Agenda Item # 19

SUB-002881-2024

Village at Tate Farms Subdivision

VILLAGE AT TATE FARMS SUBDIVISION

DETAIL SITE PLAN

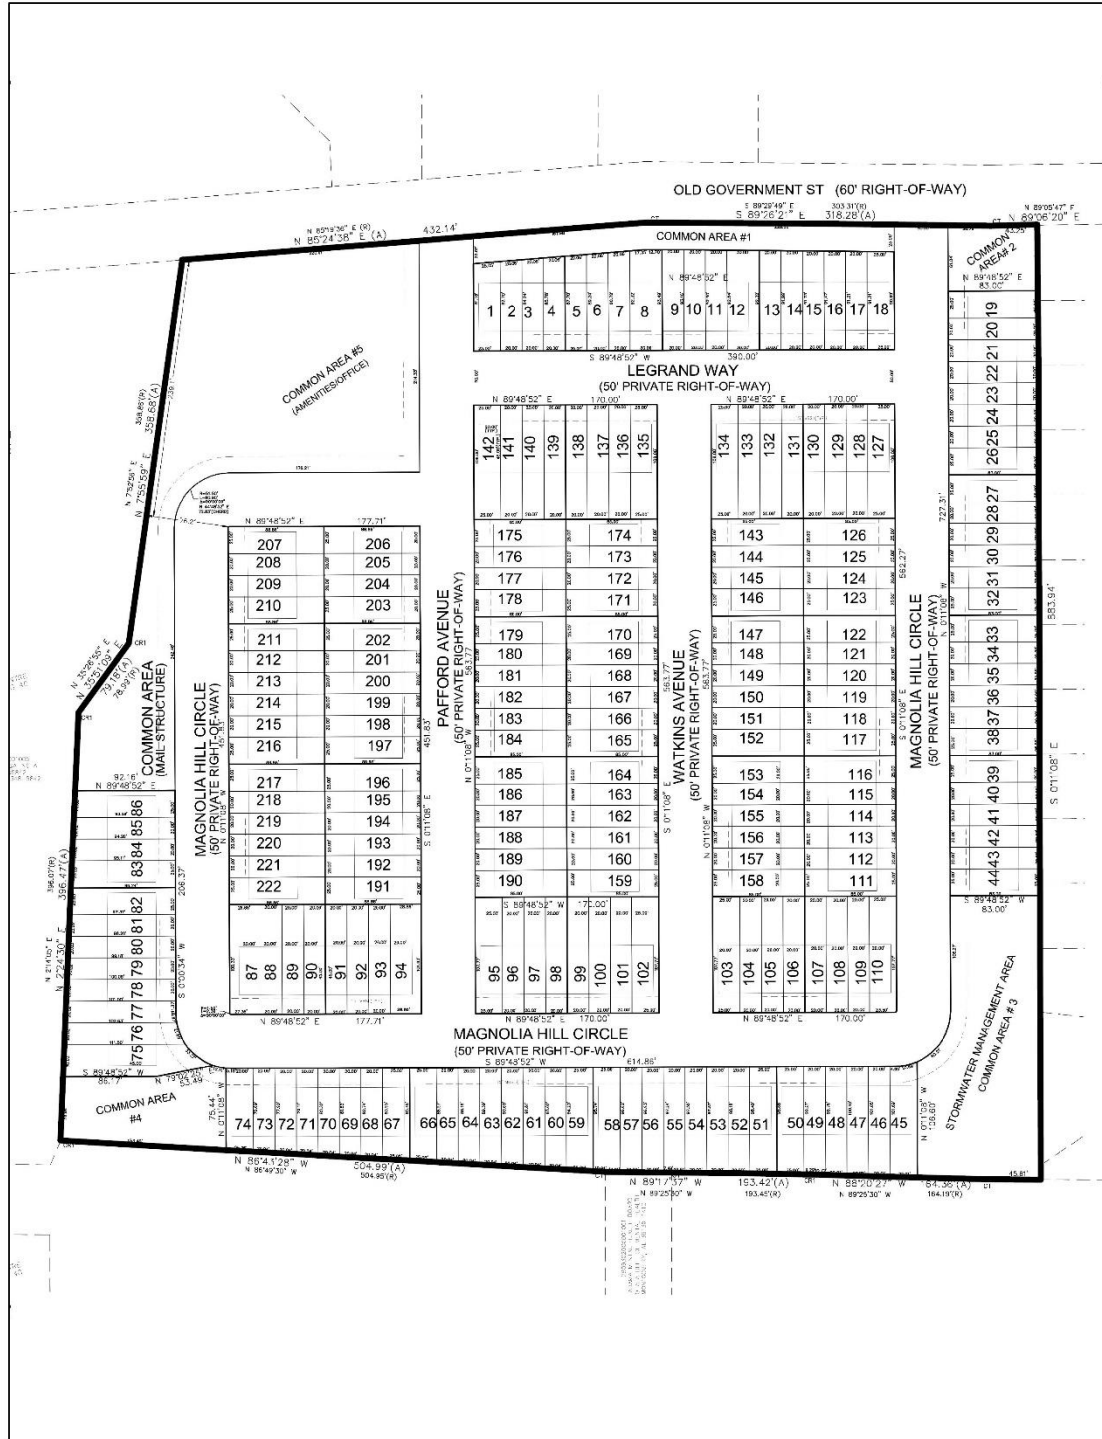
- B. The 2-page, revised Plat that was submitted contained two (2) sheets that were similar and were labeled SHEET NO. 1 OF 3.
- C. Correct the name of Old Government St. to Old Government Street Rd.

- D. Check the written legal description and the Plan bearings and distances along the Old Government Street Rd. ROW.
- E. Delete the FLOOD DAMAGE PREVENTION ORDINANCE NOTE. The note references a Mobile County document and this project is located within the limits of the City of Mobile.

- K. Add a note that all easements shall remain in effect until vacated through the proper Vacation process.
- L. The proposed PRIVATE roads contain substandard corner and centerline radii that will prevent it from being accepted for public maintenance in the future.

There are multiple corner lots, each requiring a 25-foot corner radius where the private streets will intersect, per Section 6.C.6. of the Subdivision Regulations. This information is not provided on the preliminary plat; therefore, if approved, the plat should be revised to illustrate a 25-foot corner radius where each lot abuts a private street intersection.

A table on the preliminary plat indicates the average lot size for lots within the proposed subdivision is 1,977± square feet, which is incompatible with the minimum size requirement for lots served by public water and sanitary sewer in the R-3 suburban district. Per Article 2, Section 64-2-7.E. of the UDC, the minimum lot size for lots in the R-3 Suburban district is 10,000 square feet. As such, a waiver of Section 6.C.2.(a) of the Subdivision Regulations is required for approval of the request.

None of the lots meet the minimum 60-foot width requirement of Section 6.C.2(b)(2) for residential lots located within the suburban sub-district. As such, a waiver of Section 6.C.2(b)(2) of the Subdivision Regulations will be required for approval of the request.

Four (4) common areas are proposed. No information regarding each of their sizes is depicted, as required by Section 5.A.2(f). A table on the preliminary plat indicates "Common Area Size" is 9.57 acres, but does not detail the size of each proposed common area. As such, if approved, each common area should be labeled with its size in both square feet and acres on the Final Plat; or provision of a table on the Final Plat with the same information will suffice.

A 15-foot front yard setback is illustrated on each proposed lot and common area, which is incompatible with the minimum 25-foot front yard setback requirement of Article 2, Section 64-2-6.E. of the UDC for lots in the R-3 Suburban district. As such, if approved, the Final Plat should be revised to illustrate a 25-foot front yard setback along each street frontage, unless a Variance allowing reduced setbacks is approved by the Board of Zoning Adjustment.

1. Approval of the proposed street names by the City Engineer, with any modifications labeled on a revised plat;
2. Revision of the plat to illustrate a 25-foot corner radius where each lot abuts a private street intersection, in compliance with Section 6.C.6. of the Subdivision Regulations;
3. Revision of the plat to illustrate the applicable utility easements;
4. Placement of a note on the revised plat stating that the streets are privately maintained and that there shall be no public right-of-way, in compliance with Sections 9.D.1(b)(5) and 9.D.1(b)(7) of the Subdivision Regulations;

7. Revision of the plat to label each lot with its size in square feet and acres, or provision of a table on the Final Plat with the same information;
8. Revision of the plat to label each common area with its size in square feet and acres, or provision of a table on the Final Plat with the same information;

10. Revision of the plat to illustrate a 25-foot front yard setback along each proposed street, in compliance with Section 6.C.8. of the Subdivision Regulations, and with Article 2, Section 64-2-6.E. of the Unified Development Code, or acquisition of the necessary variances;
